From: Annie_Chang@adt.com.tw [mailto:Annie_Chang@adt.com.tw]
Sent: Thursday, June 08, 2006 2:37 AM
To: steve.cheng
Subject: Re : TCB Review Comments for (C06-0607a- H4IKB27RF004- Lite On 27MKeyboard)

**TCB Review Comments for (C06-0607a- H4IKB27RF004- Lite On 27M
Keyboard)**

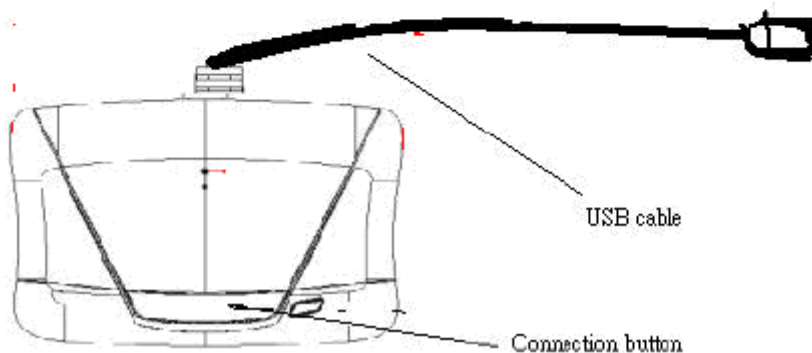
Question #1: User manual show a USB cable connected to the keyboard, please explain what is this cable for? Will this cable be connecting to PC? If yes, than this device will be considered as a PC peripheral too and its Part 15B portion needs to have DoC or Certification too.

I had upload the modified documents to server. Please find them. Thank you.
About the question 2, I upload two bandege plots to server for keyboard and mouse.
And the question 1, do you mean the 2th drawing on page 4 in the user's manual? That is receiver.

The client was added a note on page 4 in user's manual as follows:
